**AGENDA**  
**CITY PLANNING COMMISSION**

Subject: Basic Development Plan and Rezoning - Takhar Oil  
(Truck Stop, Diesel Repair Shop and Convenience Store)  
Revised Site Plan Review

ST RT 235, HUBER HEIGHTS, OH  
BASIC DEVELOPMENT PLAN

Subject: BDP 22-11 Rezoning, Combined Basic & Detailed Development Plan  
Addington Subdivision

DATE: 3/18/2022  
SHEET: 07 of 12

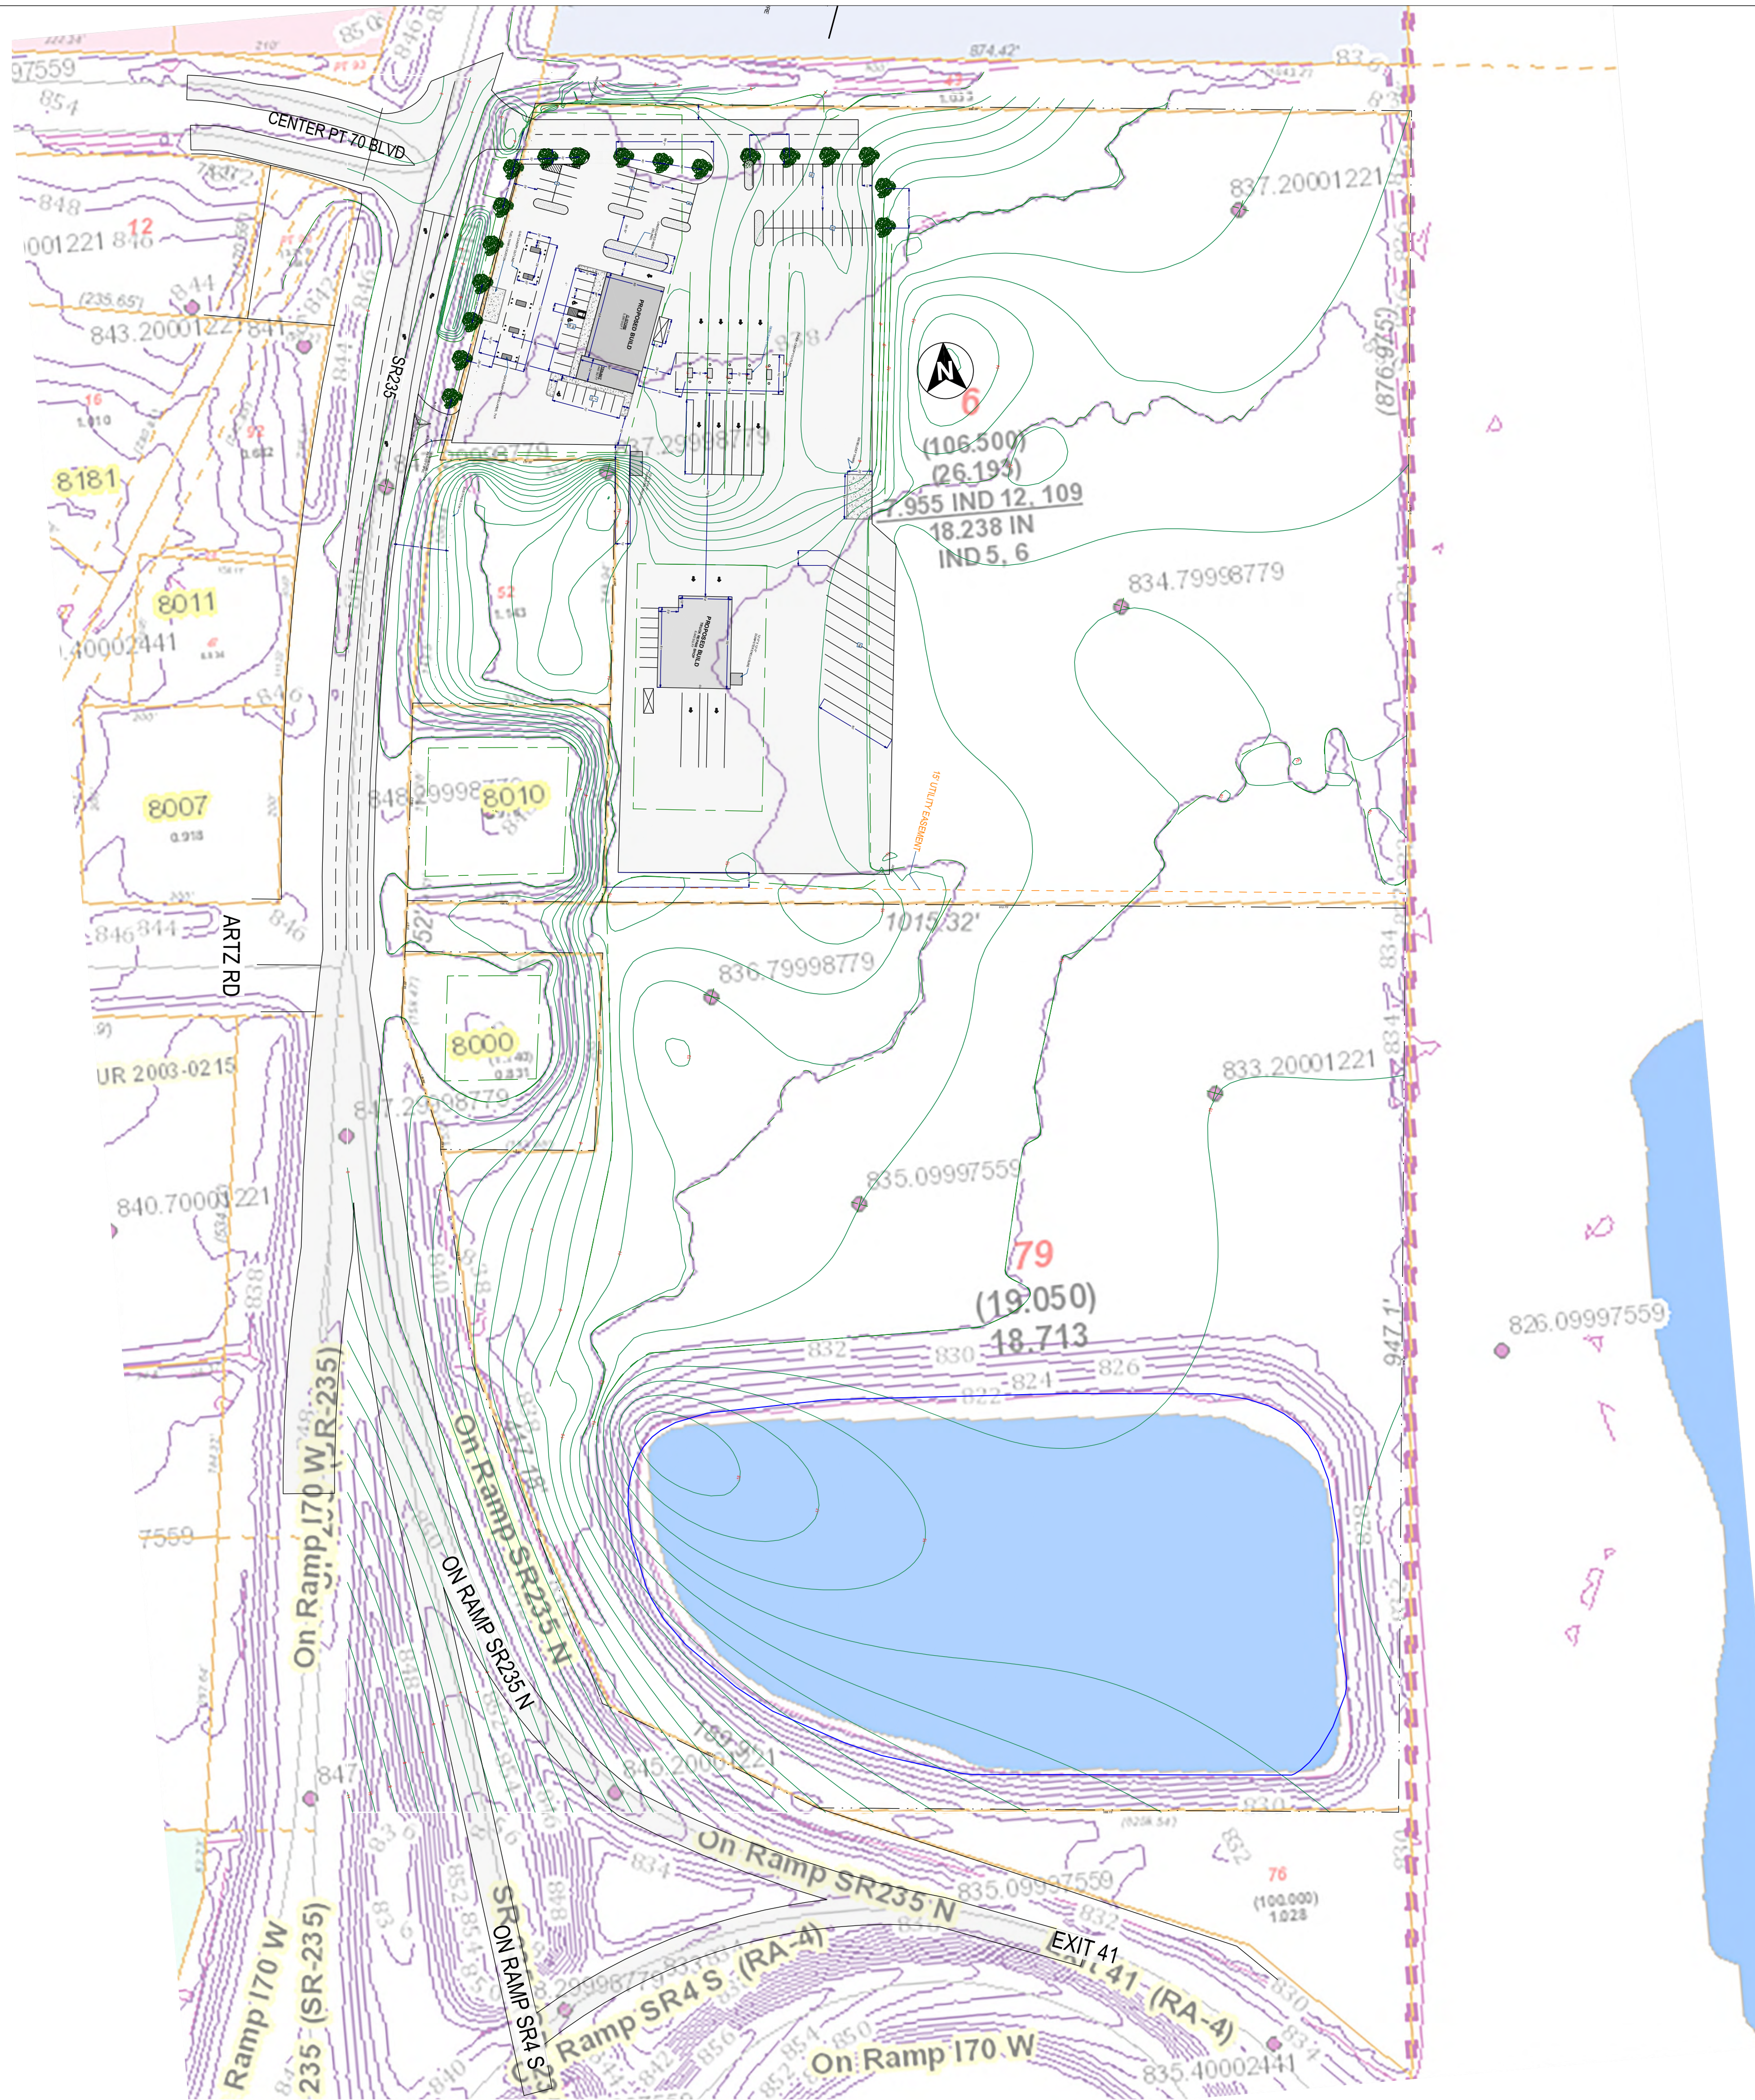
Parking is provided throughout the site. The revised site plan illustrates 76 parking spaces, including 10 for semi-trucks. This is an increase from 62 automobile parking spaces.

The proposed uses are principally permitted in the PC district. The revised plan indicates a 15-foot perimeter buffer yard, which meets the standards for this chapter. All other standards for this Chapter are met.

The revision meets the requirements of Chapter 1181. The revised plans illustrate street trees placed every 40-feet. No exterior lighting plan was submitted at this time, but will be submitted at the time of detailed development review. Unless otherwise directed by the Planning Commission, parking light fixtures shall not exceed 25 feet in height.

The revised proposal meets the requirements of Chapter 1185. The applicant is illustrating parking island landscaping. The maximum required number of parking spaces required is approximately 67 total spaces. The revised plan indicates 70 proposed spaces. The number of required parking spaces is likely to decrease once the final area of the convenience store (less storage) and restaurant are determined.

The proposal meets the requirements of this chapter which limits the number of semi parking spaces to no more than ten spaces. The plans indicate ten spaces that are correctly dimensioned.

Staff has asked the applicant to redesign the site to allow a future extension of Center Point 70 by moving the gas pumps and store further south and/or changing their alignment. The applicant has adjusted the site plan by reconfiguring the parking and circulation plan. The revised configuration will likely improve vehicle stacking at the intersection along the proposed roadway, rather than internally as was originally illustrated.
